SUNDRY NOTICES AND REPORTS ON WELLS (DO NOT USE THIS FORM FOR PROPOSALS TO DRILL OR TO DEEPEN OR PLUG BACK TO A DIFFERENT RESERVOIR. USE "APPLICATION FOR PERMIT" (FORM C-101) FOR SUCH PROPOSALS.)		WELL API NO. 30-015-53724

2. Name of Operator Mewbourne Oil Company		6. State Oil & Gas Lease No.
3. Address of Operator P.O. Box 5270 Hobbs, NM 88241		7. Lease Name or Unit Agreement Name Full Tilt 18/7 Fed

Mewbourne Oil Company requests to make the following changes to the APD:

Operator: MEWBOURNE OIL CO P.O. Box 5270 Hobbs, NM 88241	OGRID: 14744
	Action Number: 216114
	Action Type: [C-103] NOI Change of Plans (C-103A)

WELL LOCATION AND ACREAGE DEDICATION PLAT

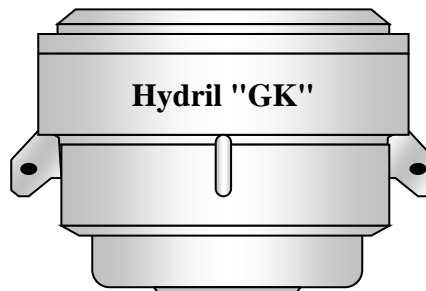
- Change SHL from 500' FSL & 1511' FEL (Sec 18, T26S, R30E) to 490' FSL & 1511' FEL (Sec 18, T26S, R30E). Please see attached updated C102
- Change BHL from 2430' FSL & 1650' FEL (Sec 7, T26S, R30E) to 2560' FSL & 380' FEL (Sec 7, T26S, R30E). Please see attached updated C102
- Change zone from Purple Sage; Wolfcamp (Gas) to Corral Canyon; Bone Spring, South
- Change BOP/BOPE from 10M rating to 5M rating
- Change Casing/Cement/Mud program
- Please see attached drilling program and other documentation referencing design changes and data that corresponds to said procedural alterations.

5M BOPE & Closed Loop Equipment Schematic

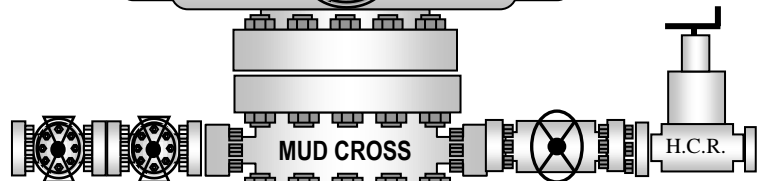
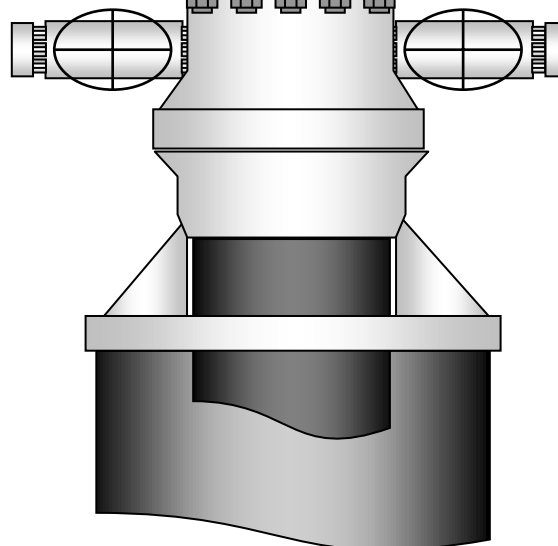
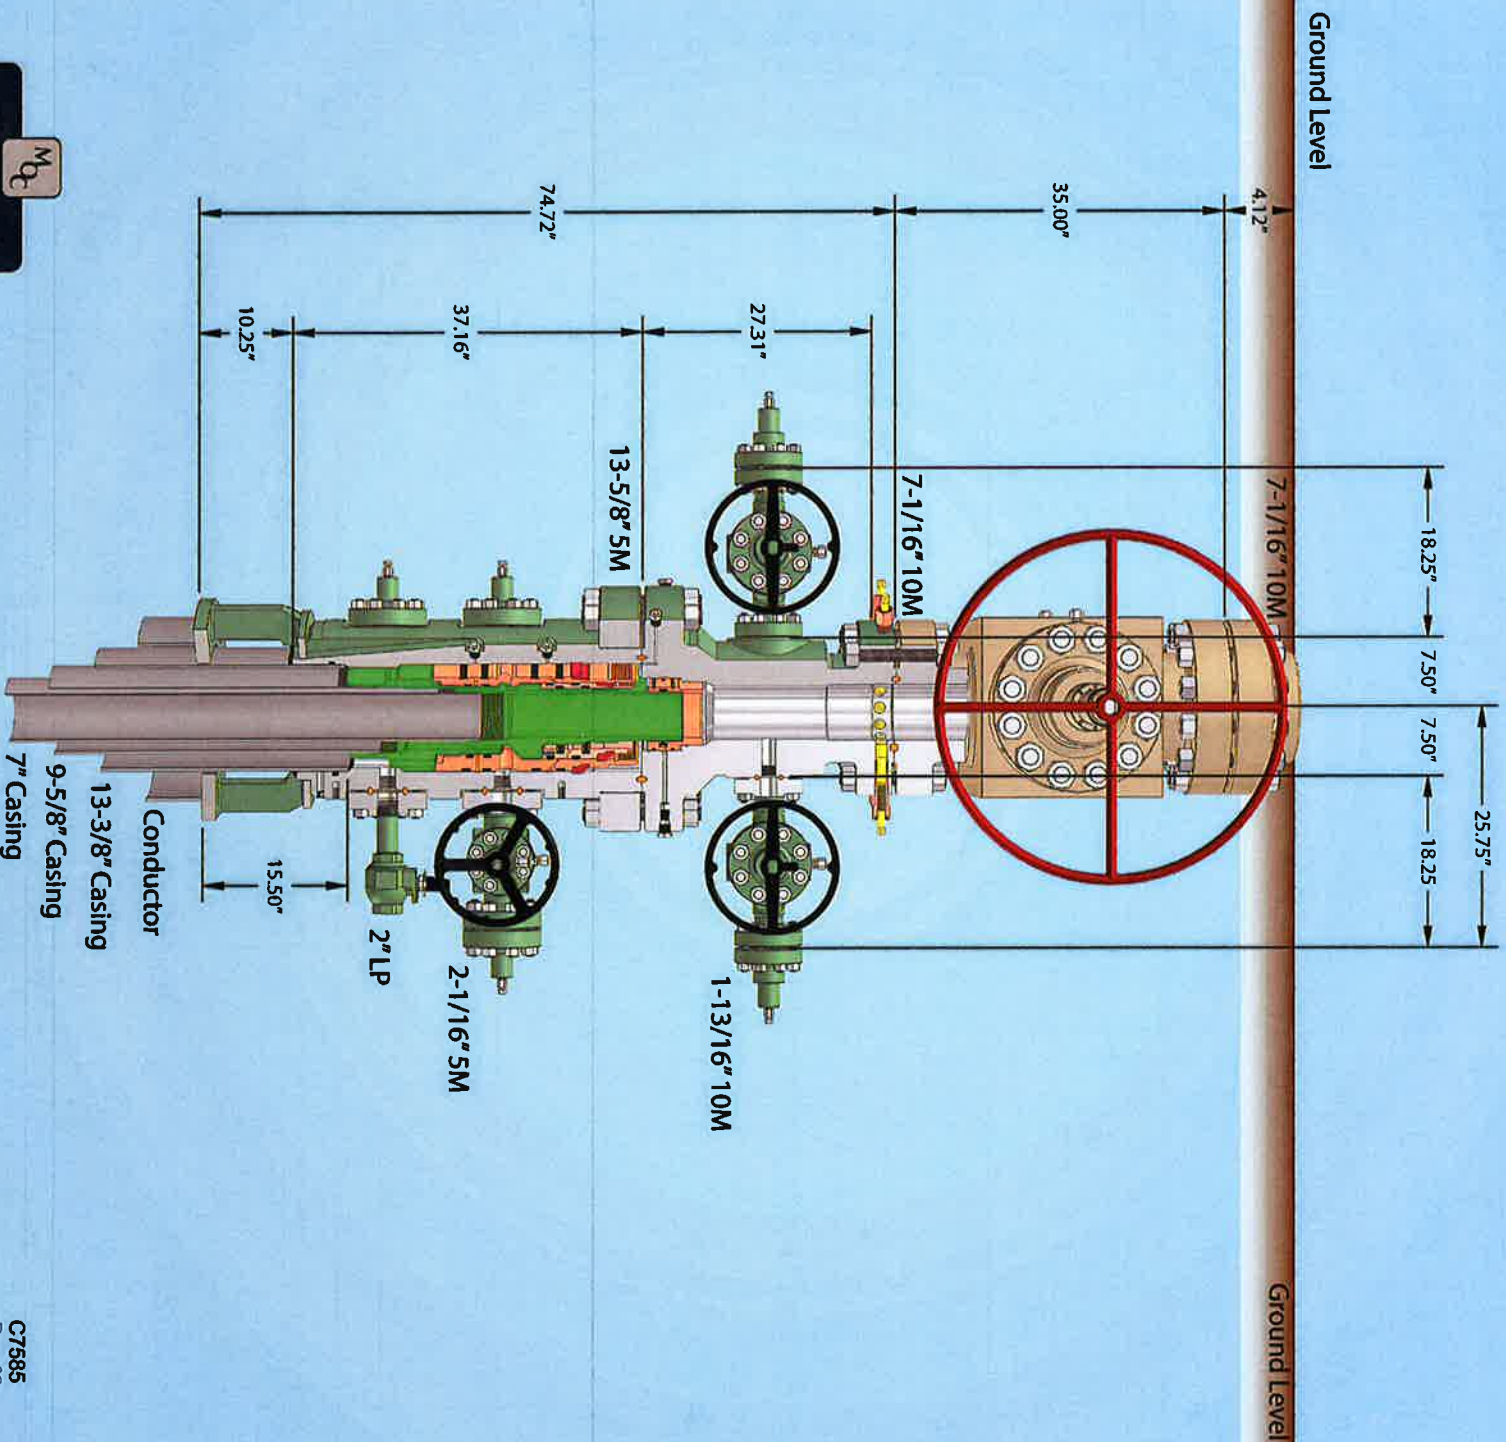
Blowout Prevention**Pressure Rating:** 5M**Equipment:** Annular, Pipe Rams, Blind Rams**Requesting Variance:** YES

Testing Procedure: BOP/BOPE will be tested by an independent service company to 250 psi low and the high pressure indicated above per Onshore Order 2 requirements. The System may be upgraded to a higher pressure but still tested to the working pressure listed in the table above. If the system is upgraded all the components installed will be functional and tested. Pipe rams will be operationally checked each 24 hour period. Blind rams will be operationally checked on each trip out of the hole. These checks will be noted on the daily tour sheets. Other accessories to the BOP equipment will include a Kelly cock and floor safety valve (inside BOP) and choke lines and choke manifold. See attached schematics.

1. Variance approved to use flex line from BOP to choke manifold. Manufacturer's specification to be readily available. No external damage to flex line. Flex line to be installed as straight as possible (no hard bends).^{*}

2. Operator has proposed a multi-bowl wellhead assembly. This assembly will only be tested when installed on the surface casing. Minimum working pressure of the blowout preventer (BOP) and related equipment (BOPE) required for drilling below the surface casing shoe shall be **5000 (5M)** psi.
